MS9123A
AMENDMENT 1
8 July 2003

SCREW, MACHINE, SLOTTED HEX HEAD, .250-28

This amendment forms a part of MS9123A, dated 28 February 1984, and is approved for use by all Departments and Agencies of the Department of Defense.

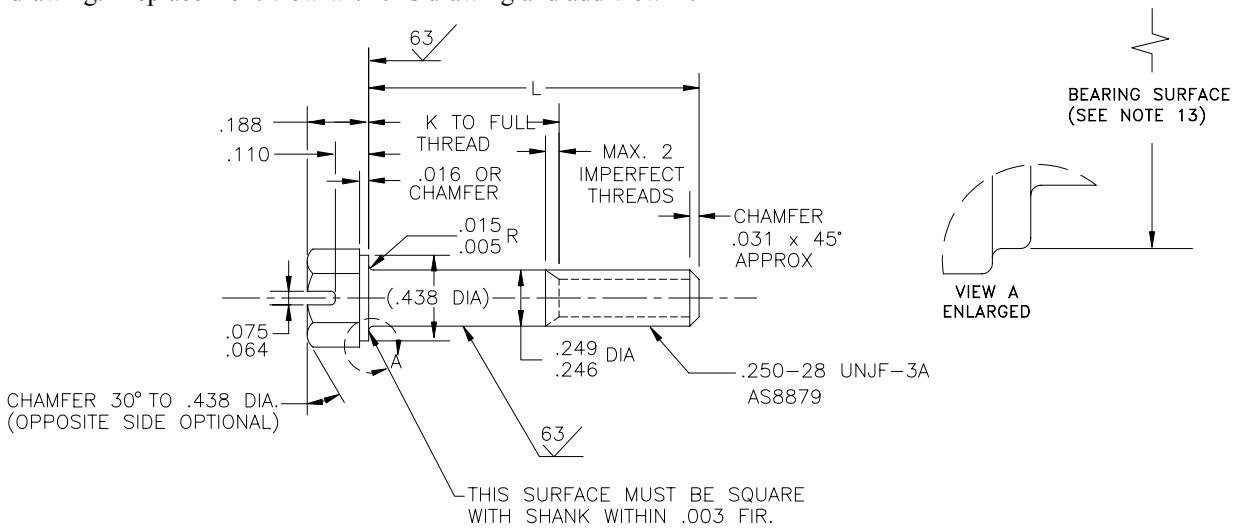
In drawing: Replace front view with this drawing and add view A:

Add the word "NOTES:" above note 1.

Note 7: Delete "ANSI B46.1-1962" and substitute "ASME B46.1".

Note 8: Delete "AMS 7452" and substitute "AS7452".

Add new note: "13. BEARING SURFACE: BEARING SURFACE SHALL BE FLAT AND WASHER FACED. DIAMETER OF BEARING SURFACE SHALL BE EQUAL TO THE MAXIMUM WIDTH ACROSS FLATS WITHIN A TOLERANCE OF MINUS 10% IN ACCORDANCE WITH ASME B18.2.1"
